Access Compliance Report Public Rights-of-Way (Curb Ramps)

Main Street: WARREN_AVE Cross Street: CLARISSA_LN Location: NW

ADA ID: RPRK220121123419 Ramp Type: Type 4 - Parallel Initial Pass/Fail: Fail Overall Compliance: No Severity Score: 2

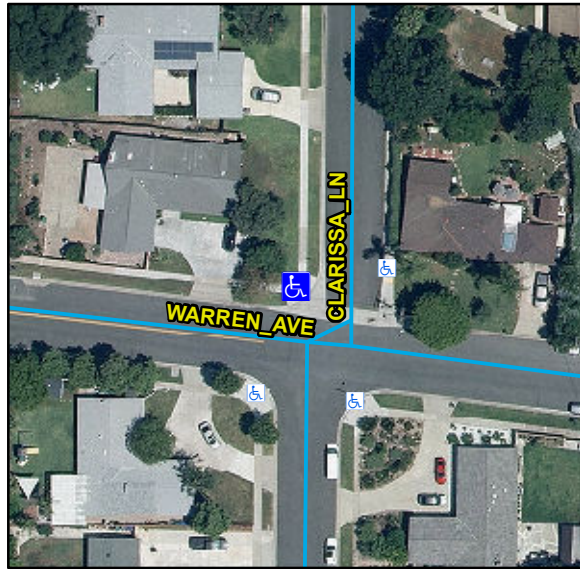
R304.5.3, STD 1115

Compliance	Description	Data	Compliance	Description	Data
N/A	Ramp Length LT (in)	87	N/A	Ramp Length RT (in)	88
Yes	Ramp Width LT (in)	122	Yes	Ramp Width RT (in)	122
Yes	Ramp Run Slope LT (%)	4.2	Yes	Ramp Run Slope RT (%)	4.5
No	Ramp Cross Slope LT (%)	2.9	No	Ramp Cross Slope RT (%)	3.6
N/A	Landing Present	N/A	N/A	DWS Provided	N/A
N/A	Landing Length (in)	N/A	N/A	DWS Contrast	N/A
N/A	Landing Width (in)	N/A	N/A	DWS Length (in)	N/A
N/A	Landing Run Slope (%)	N/A	N/A	DWS Full Width	N/A
N/A	Landing Cross Slope (%)	N/A		DWS Offset Type	N/A
N/A	Landing Movement Obstructed?	N/A	N/A	DWS Offset Left (in)	N/A
	Landing Movement Type	N/A	N/A	DWS Offset Right (in)	N/A
N/A	Landing Shared	N/A			
N/A	Clear Space	Yes			
N/A	Clear Space To Crosswalk (in)	N/A			
N/A	Marked Crosswalk 1	No	N/A	Marked Crosswalk 2	No
	Crossing 1 Direction	S		Crossing 2 Direction	E
	Marked Crosswalk 1 Width (in)	N/A		Marked Crosswalk 2 Width (in)	N/A

Remove & Replace Curb Ramp With Two New Directional Ramps or Equivalent.
